PROJECT BRIEF

Historic District Board of Review Application for Certificate of Appropriateness at 313 E. First St. to replace 9 wood windows with 9 vinyl windows of same size, shape, and design.

Application Date: November 28, 2022
HDBR Meeting Date: January 23, 2023

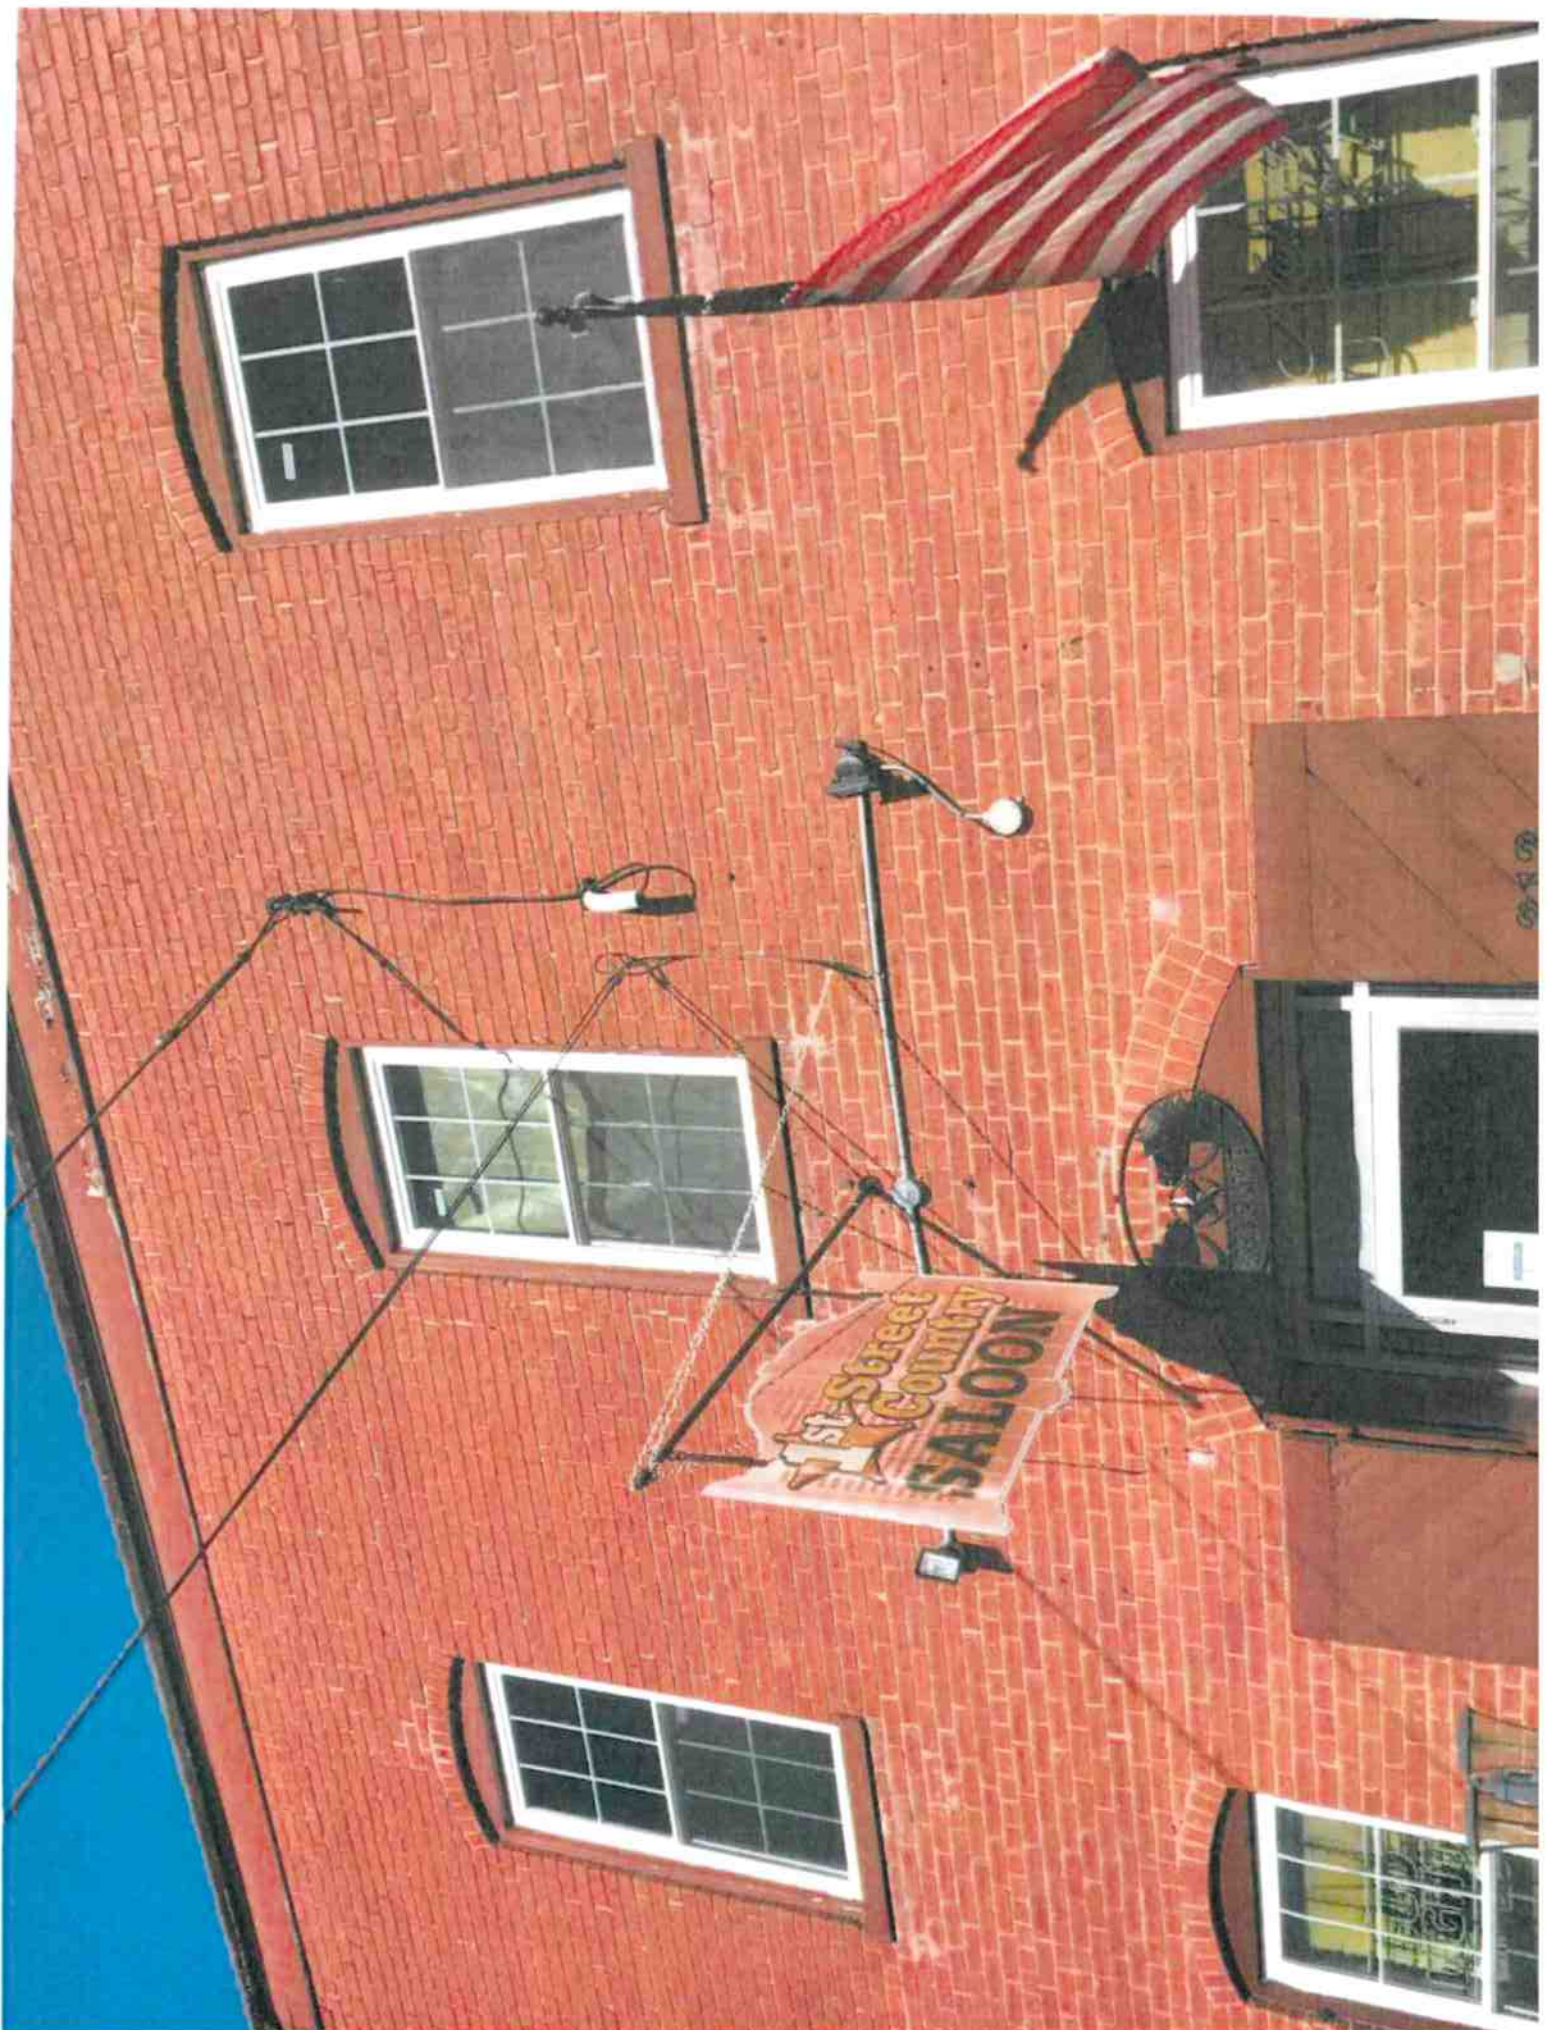
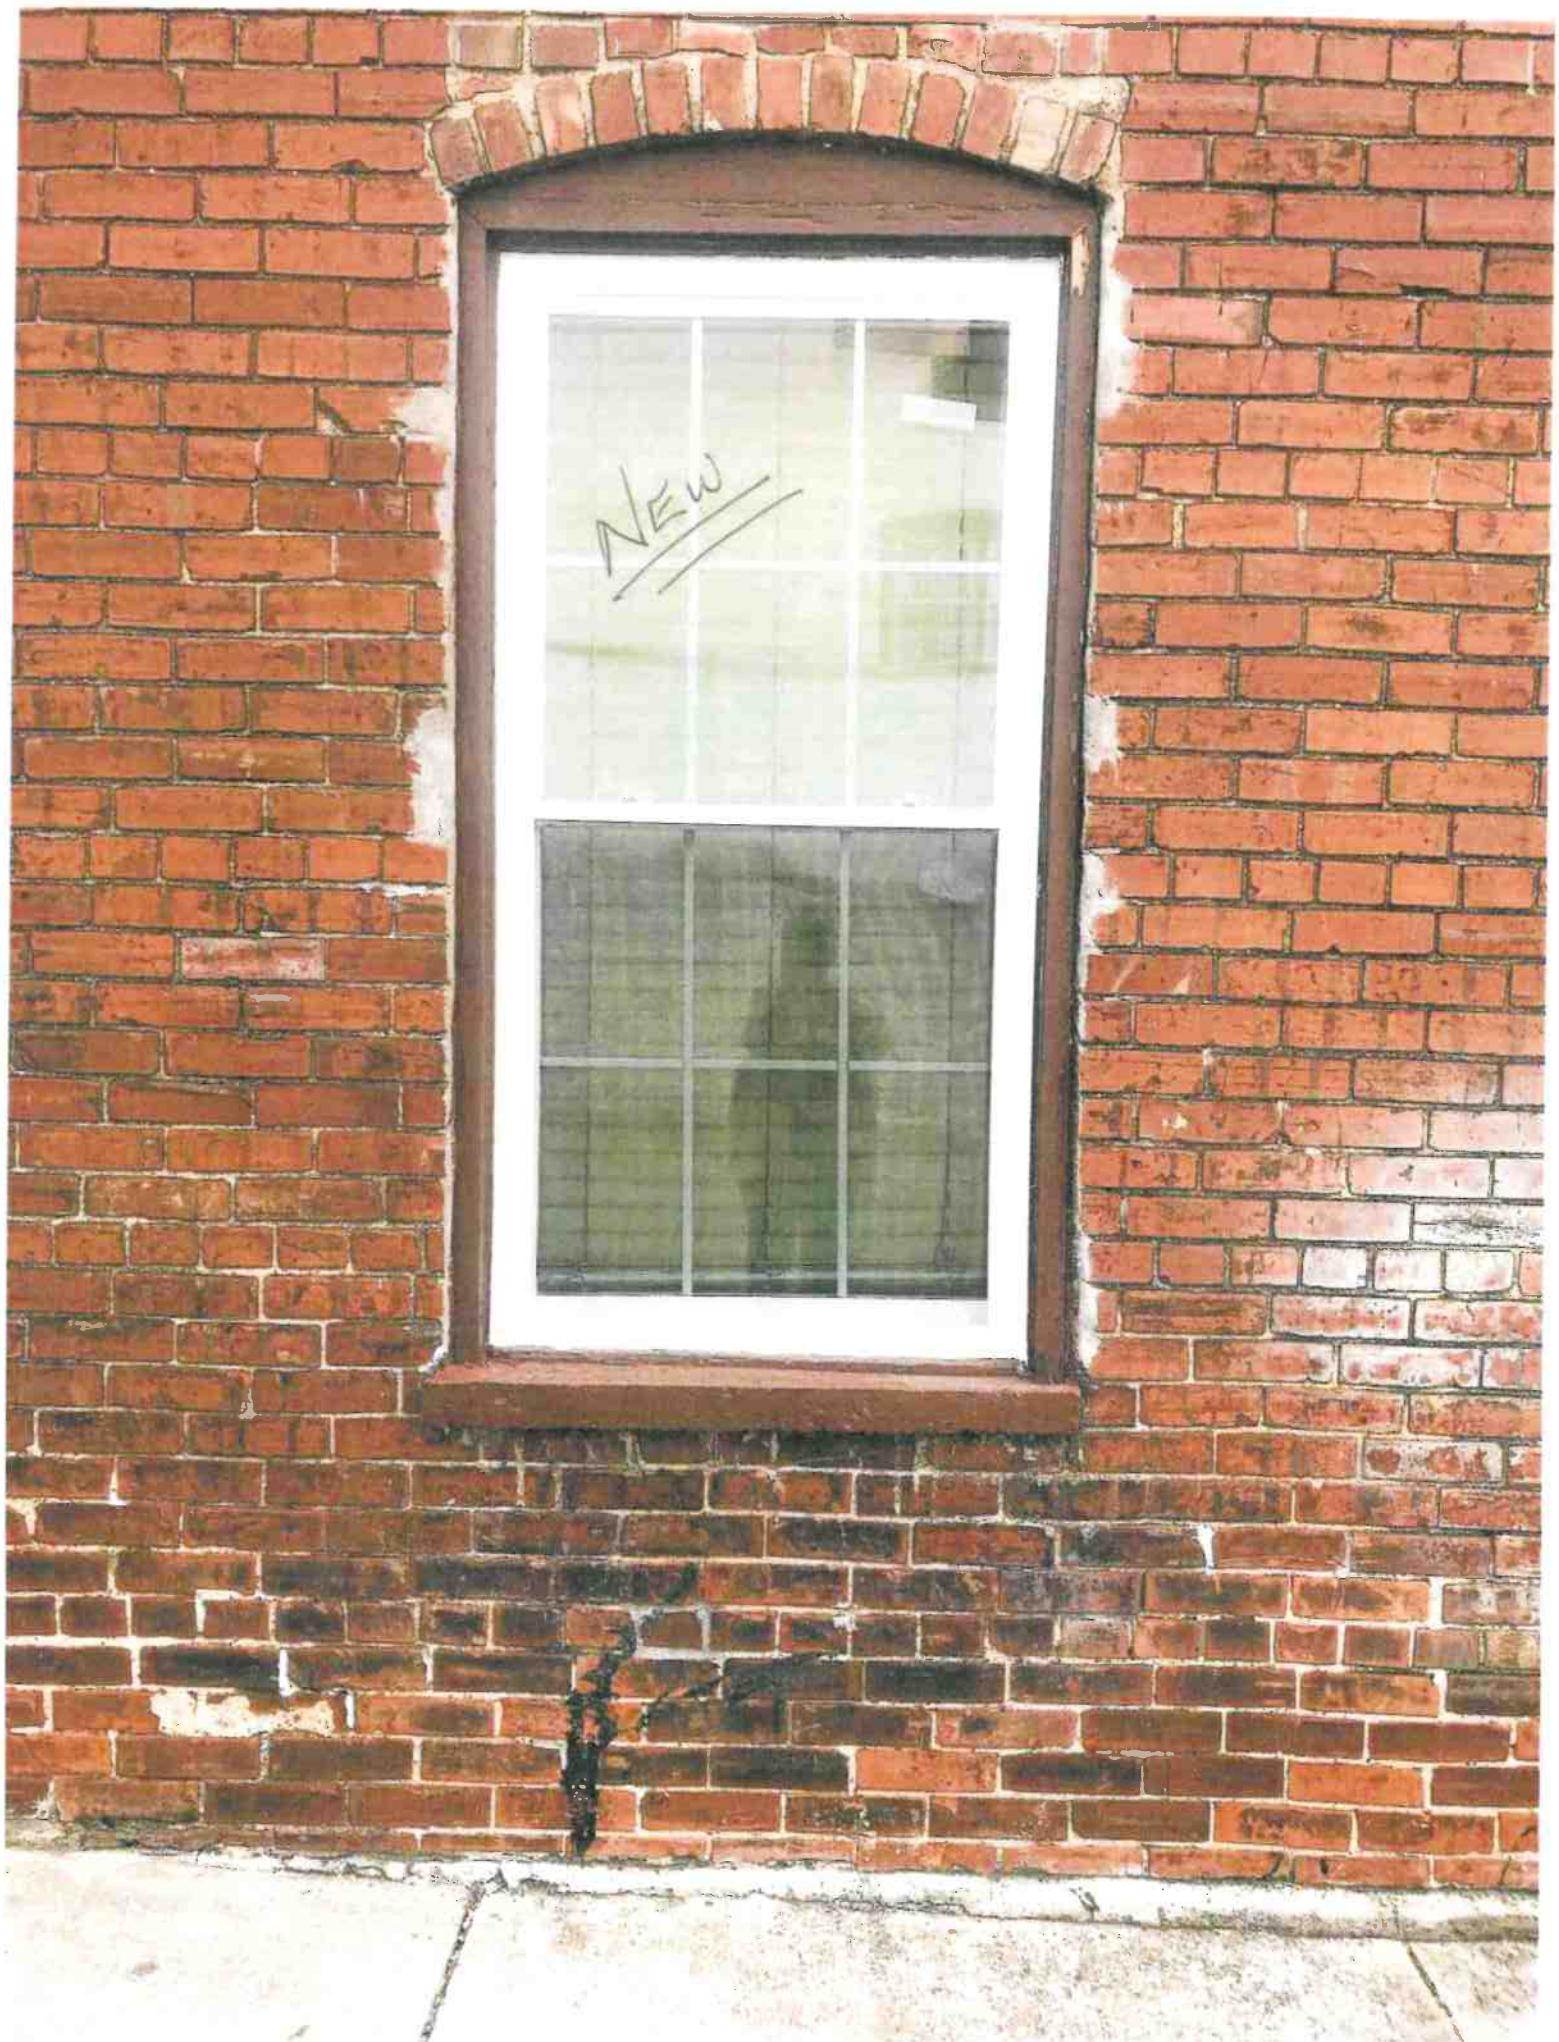
Staff did not do an inspection of the windows prior to their replacement, but based on photographic evidence and street view visibility, the wood windows did not appear to meet the 80% deterioration criteria for replacement. The windows were replaced without an approved COA. Work was completed prior to the filing of the application.

The project is *not* in conformance with Guidelines 18.1-18.4 or 18.7 because the historic windows were removed rather than repaired, there was no evidence of 80% or higher deterioration, and the replacement windows do not match the original in material or massing because the vinyl windows have internal muntins that do not adequately replicate the bulkier exterior muntins of the historic windows; is *not* in conformance with the ordinance because the replacement windows are not compatible in terms of material and texture; is *not* in conformance with SIS for Rehabilitation 2, 5-6 because the removal of the historic windows does not preserve the historic material nor retain the historic character, does not adhere to the standard for repair over replacement when possible, and the replacement windows do not match the historic in material or texture (muntin profile & dimension).

Your property is in violation of this ordinance due to the unapproved removal of the wood windows and installation of new vinyl windows on the south and west facades. This office asks that you file for a Certificate of Appropriateness with the Historic District Board of Review as soon as possible or remove the unapproved windows and replace them with the previous windows within thirty (30) days. Applications may be obtained online on the City's website or at the Office of Historic Preservation, City Hall, 101 West Main Street.
